Meeting Date: Tuesday 2 September 2014
Location: Committee Room 2, Level 5, Civic Centre, 1 Devlin Street, Ryde
Time: 5.00pm

Item	Page
1 CONFIRMATION OF MINUTES - Meeting held on 19 August 2014.....	1
2 6 JETTY ROAD, PUTNEY. LOT 5 DP 17893. Local Development Application for New part 2 / part 3 storey dwelling house. LDA2013/0472.	5

Report prepared by: Assessment Officer - Town Planner; Team Leader -
Assessment**Report approved by:** Manager Assessment; Group Manager - Environment &
Planning**Report dated:** 11/08/2014 **File Number:** GRP/09/5/6/2 - BP14/1014

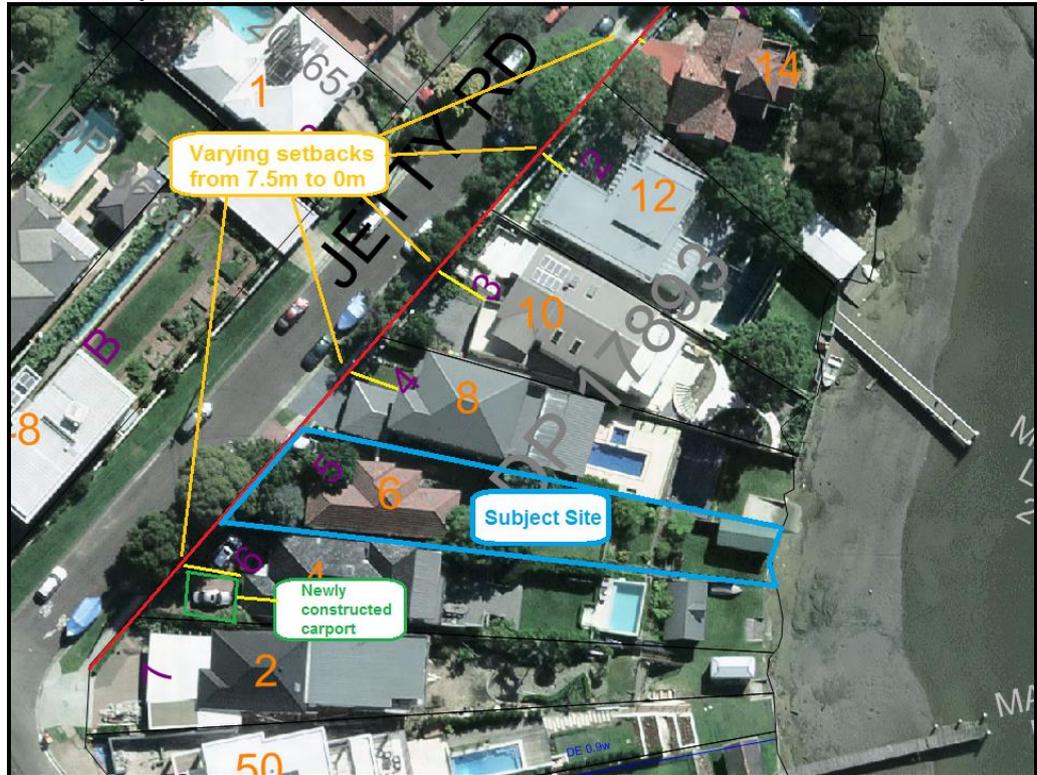
- B. *Setbacks.*** *Concerns are raised that the proposed development does not comply with the front and side setback controls stipulated in the Ryde DCP 2010.*

Council's DCP 2010: Part 3.3 Dwelling Houses & Dual Occupancy (attached) – Section 2.8 'Setbacks' states:

- Dwellings are generally to be set back 6 metres from the street front boundary.
- The outside walls of a single storey dwelling are to be set back from the side boundaries not less than 900mm.
- The outside walls of a two storey dwelling are to be set back from the side boundaries not less than 1.5m.

Ground floor side setback distances

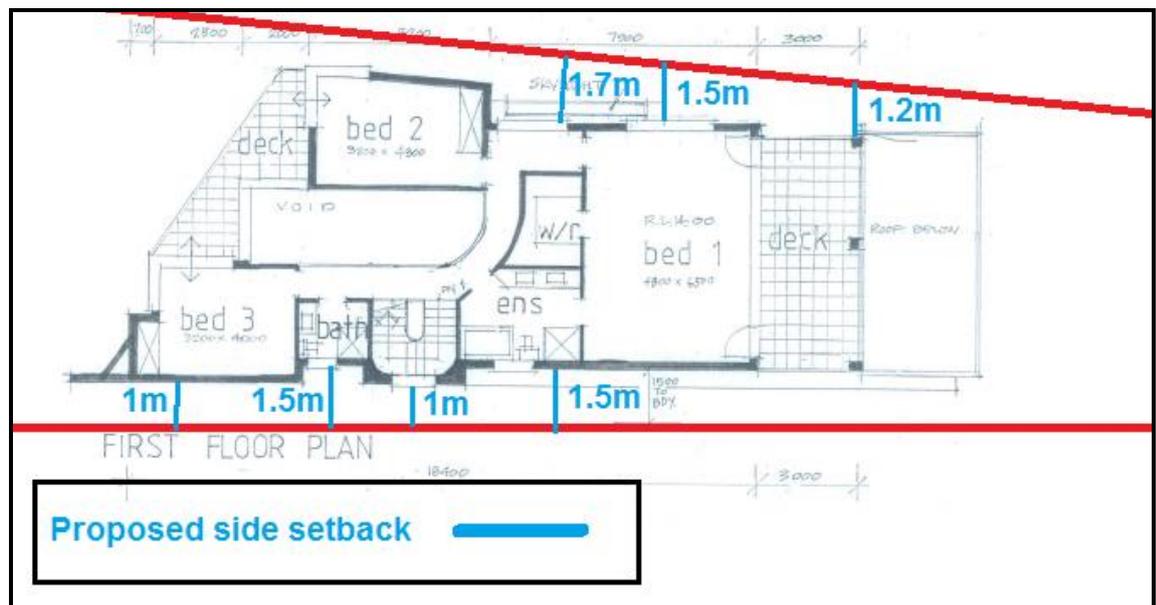
Along the northern side, the lower ground floor is set back 1.25m, the ground floor has setbacks varying between 1m to 1.5m and the first floor has setbacks varying between 1m to 1.5m. The applicant has provided a ground floor plan which shows the siting of dwellings either side of the site.

A mark-up of this plan is shown below identifying the varying setback distances at a ground floor level:

First floor side setback distances

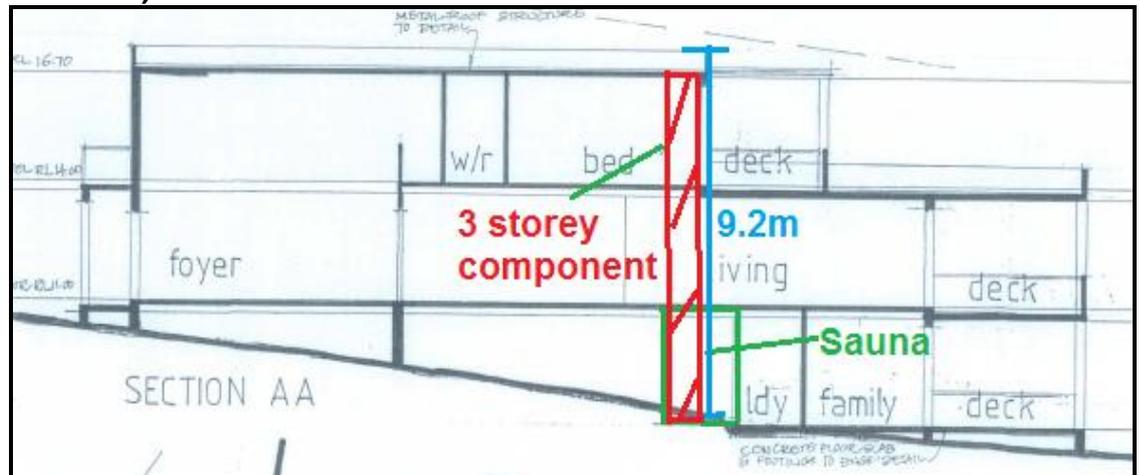
The property to the north at No. 8 Jetty Road has side setbacks varying from 900mm to 1.975m with the property to the south at No. 4 Jetty Road having a side setback distance of 1.14m.

These adjoining properties narrow towards the rear similar to the subject site however, they are both wider throughout from the front to rear boundary. The subject site has a width at the front boundary of only 14.325m, narrowing towards the water's edge with a width of only 6.8m. Taking this into account, it is seen that the proposal's side setbacks are in fact, more generous than adjoining properties with wider sites and acceptable for the site's narrow width.

The applicant complies with the 900mm setback for the ground floor component and has articulated the building along each northern and southern side elevation at the first floor level to demonstrate compliance with the 1.5m requirement at certain points.

To require the applicant to conform to the 1.5m setback on both sides of a narrow site when surrounding properties of widths greater than the subject site contain dwellings of smaller setbacks is unreasonable. Further, minimal gain would be seen from increasing the side setback to 1.5m as this would have only a marginal positive impact in terms of bulk, scale or overshadowing.

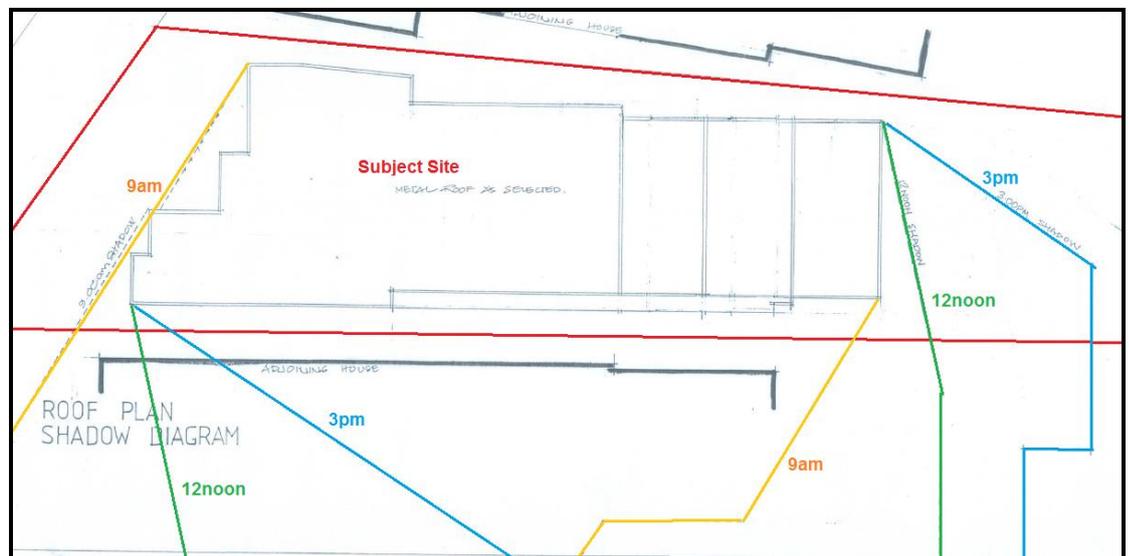
Preliminary assessment of the proposed development identified floor space ratio non-compliance as an issue. The original plans were assessed as having a floor space ratio of approximately 0.54:1. Subsequently, this concern was raised and requested to be addressed as part of Council’s additional information request dated 19 February 2014.

Amended plans received on 3 June 2014 show the overall floor space ratio of the dwelling reduced to 0.488:1 and compliant with the maximum floor space ratio requirement.

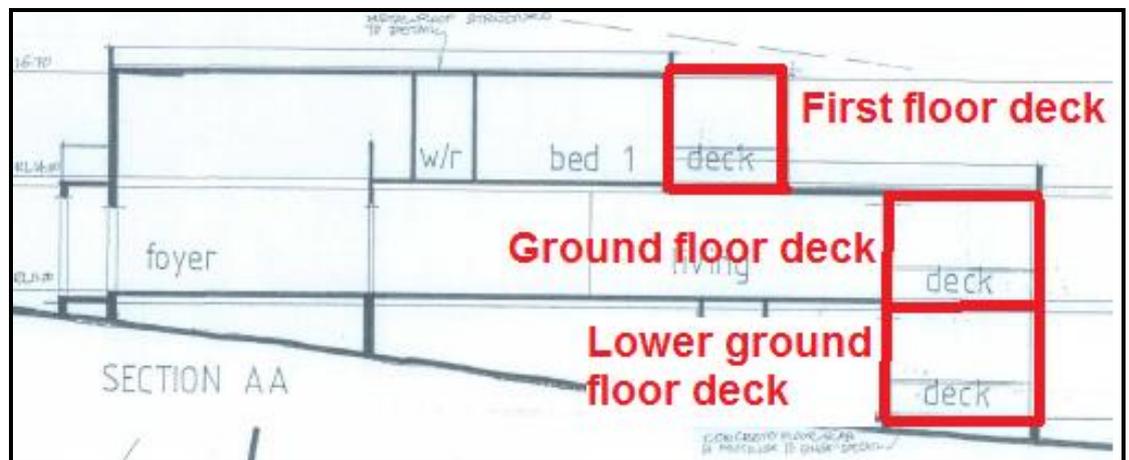
In terms of impacts on north-facing living room windows, the following photo shows that the adjoining dwelling contains a bedroom and a bathroom on the northern side, and also a sitting room with three (3) higher level windows. It is recognised that overshadowing onto the dwelling at No. 4 Jetty Road will prevent northern side windows from receiving the minimum 3 hours sunlight to a portion of their surface.

The bedroom and bathroom windows are not “living rooms” in terms of overshadowing considerations. The three (3) sitting room windows have a high sill height of 3.24m and are considered secondary windows in this room as floor to ceiling glass sliding doors in this room overlook the subject site’s rear private open space and Morrisons Bay. Therefore, the sitting room will still have the potential to gain adequate solar access.

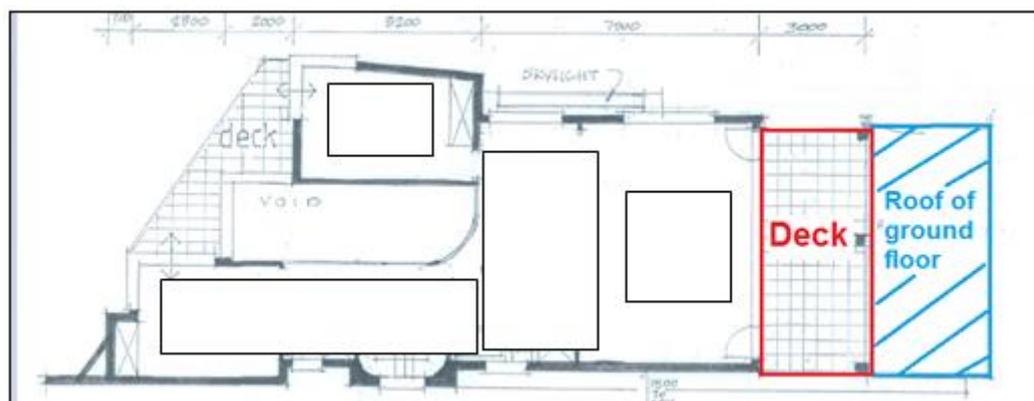
- The height of No. 8 Jetty Road, which contains a relatively recent dwelling house development, is approximately 9.2m in height, similar to the proposal. This represents a difference of 200mm and demonstrates compliance with the maximum allowable height of 9.5m at any point on the site.
- The FSR of the dwelling house is 0.488:1, which complies with the maximum allowable FSR of 0.5:1 on the site.
- The rear setback to the lower ground and ground floor (excluding rear balconies on these levels) is approximately 31m, which is substantially greater than the minimum DCP requirement of 14.28m (25% of the northern side boundary length of 57.15m in this instance). It is noted that a rear setback of 14.28m to the first floor of the dwelling house would obliterate views directed south towards Parramatta River at No. 8 Jetty Road.

The applicant has set back the first floor level a further 6m (excluding balconies) from the rear building line of the proposed dwelling which will ensure that water views gained from the first floor level of No. 8 Jetty Road are retained.

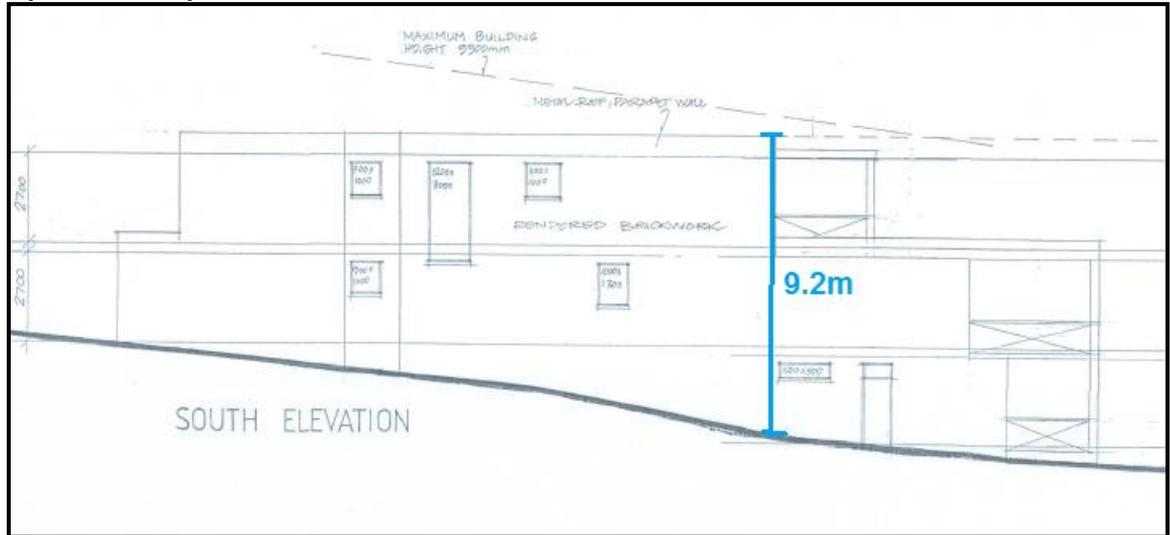
Proposed fill of 2.8m is proposed underneath the kitchen and living area. This non-compliance was raised as an issue by an objector. See discussion in the Submissions section (7.i) of this report for commentary on this non-compliance. As noted, it is proposed that the dwelling be lowered by a minimum 500mm to address the extent of this non-compliance.
